SEWAGE DISPOSAL SYSTEM

HOWARD COUNTY HEALTH DEPARTMENT

SUBDIVISION Twelve Hills

ROAD 13007 Twelve Hills Road

INDICATE NORTH - NAME ADJOINING ROADWAY AS BASE LINE Twelve Hills Rd.

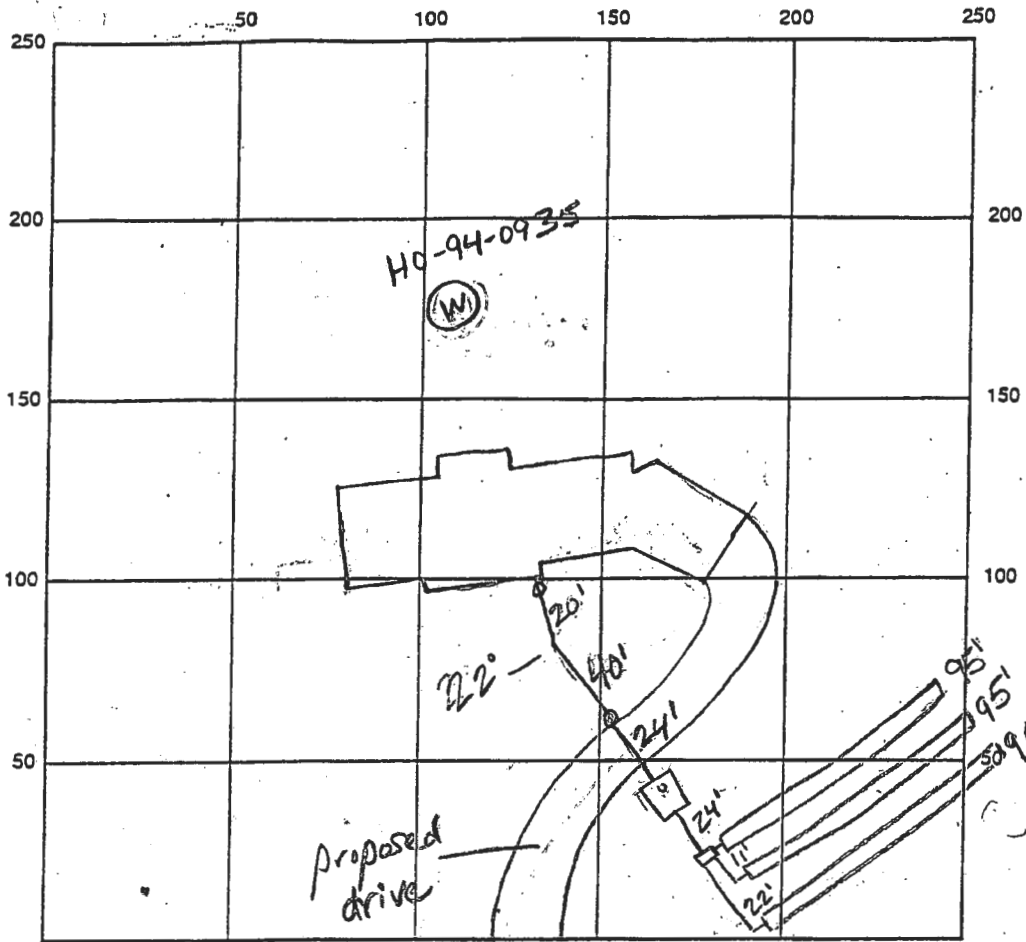
REMARKS: 8-7-98 needs house conn, ok to cover all work, box according to specs per installer (Pooley) (14m)

6/15/99 NOUSE connection ok - FINAL. DCB

LOCATION DRAWING
TWELVE HILLS ROAD

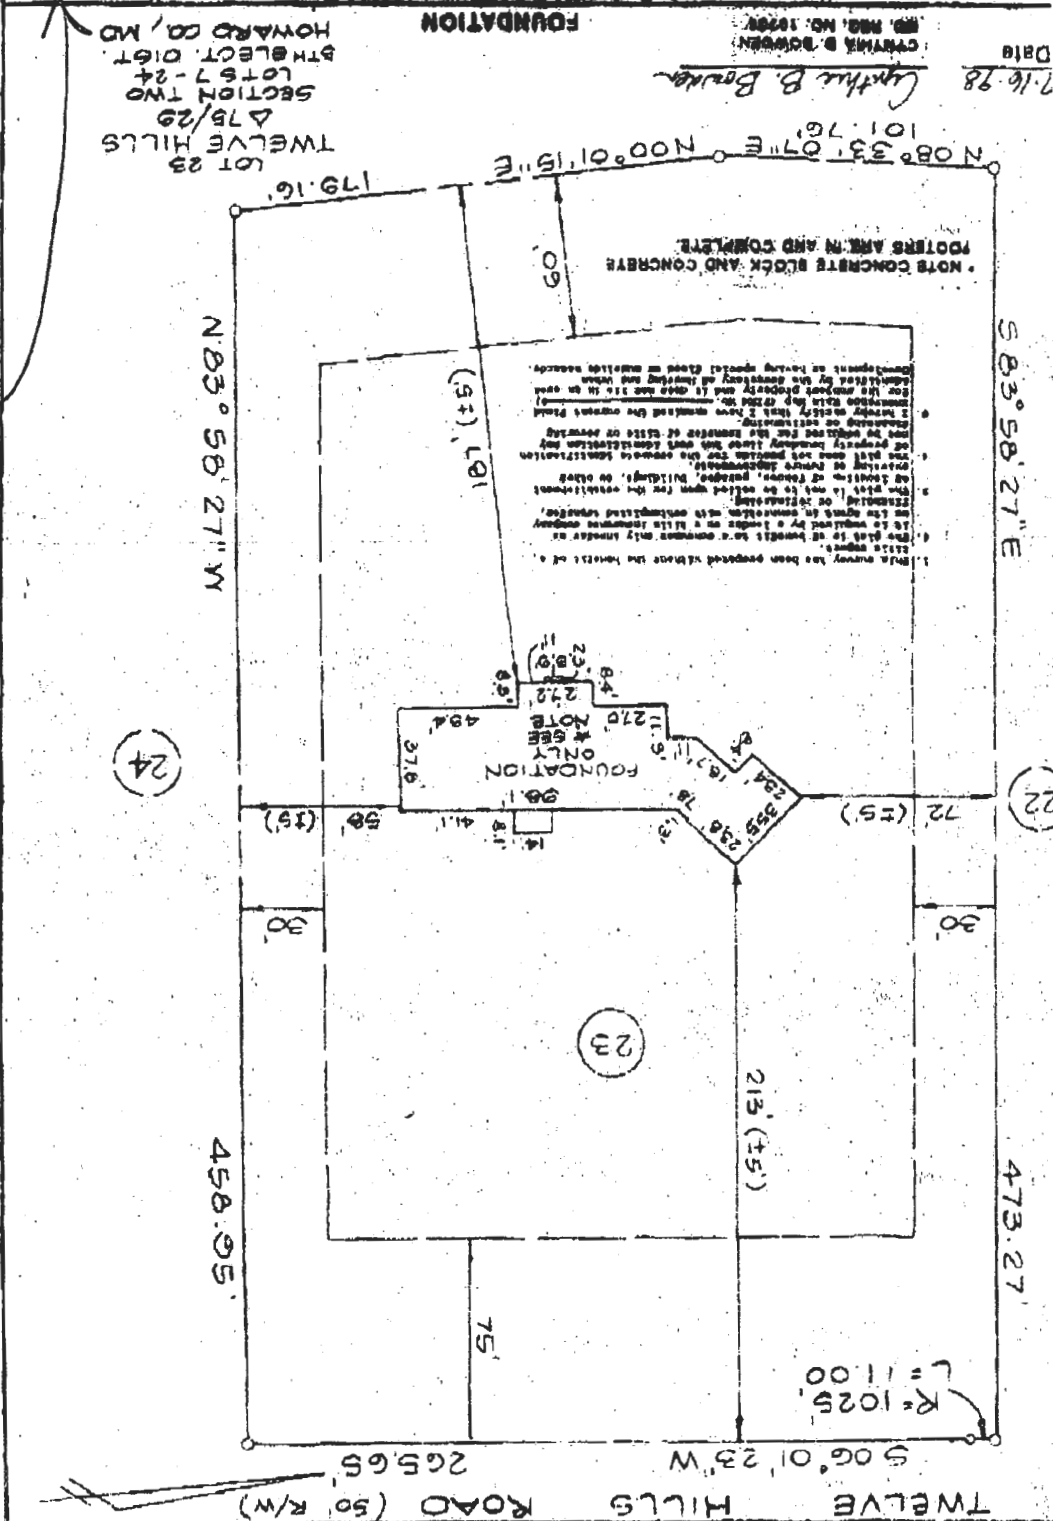
WALL
CHECK
NOT TO
1:50 SCALE
AS ORIG.
REPORTED
SLIGHTLY
LARGER
FOOTPRINT
THAN SITE
PLAN DUE
TO PORCH
ON SIDE
BLDR.
CONFIRMS
4 BR
WALL
CHECK OK
MR 8/5/98
